City of Piedmont  
CITY COUNCIL AGENDA REPORT

SUBJECT: Public Hearing – Consideration of a Resolution Adopting the Piedmont Objective Design Standards; Introduction and First Reading of Ordinance 788 N.S. Amending the City Code Chapter 17, and Consideration of a Resolution Amending the Piedmont Design Standards and Guidelines.

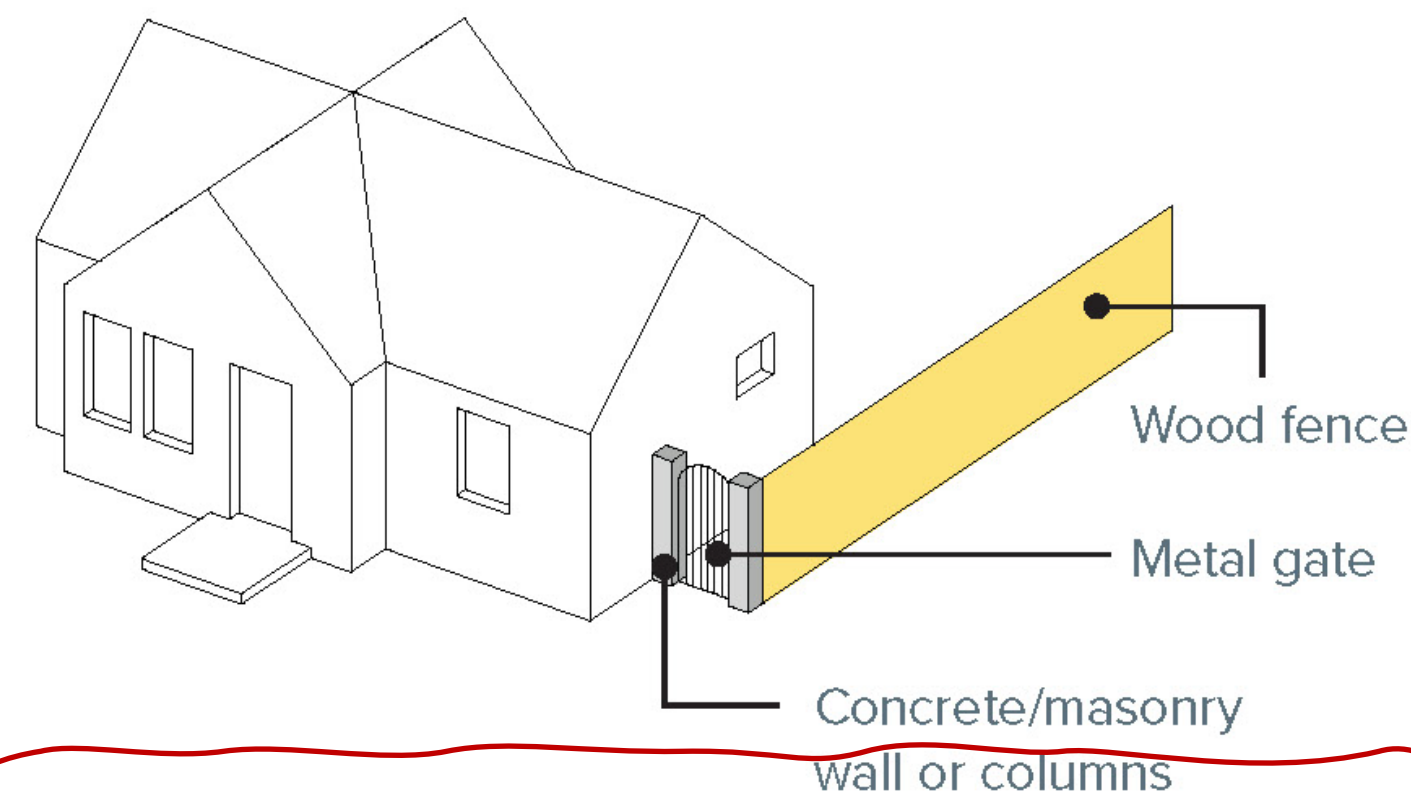
5. Section 2.7.4, Section 3.2.5 and Figure 3.2.4 (agenda report pages 51 & 78): These sections establish standards for fire-safe landscaping and fencing for ADUs and 1–4-unit developments. While they previously required projects to meet Zone Zero (0–5 ft ember-resistant zone) standards, staff and the Fire Chief now recommend eliminating this requirement. This change follows the City's reclassification out of the High Fire Hazard Severity Zone and aligns the ODS with the recently adopted Building Code, which no longer mandates Zone Zero compliance. See revised language below:

~~Figure 3.2.4: Wood fences may not be positioned within 5 feet of the structure. Any portion of the enclosure within 5 feet of the structure shall be non-combustible, such as a concrete or masonry wall and/or a metal gate.~~ Fencing shall be designed to meet the fire safe vegetation requirements as determined by the Piedmont Fire Marshal and as specified in the Wildland Urban Interface Fire Code, Part 7 of Title 24 of the California Code of Regulations.
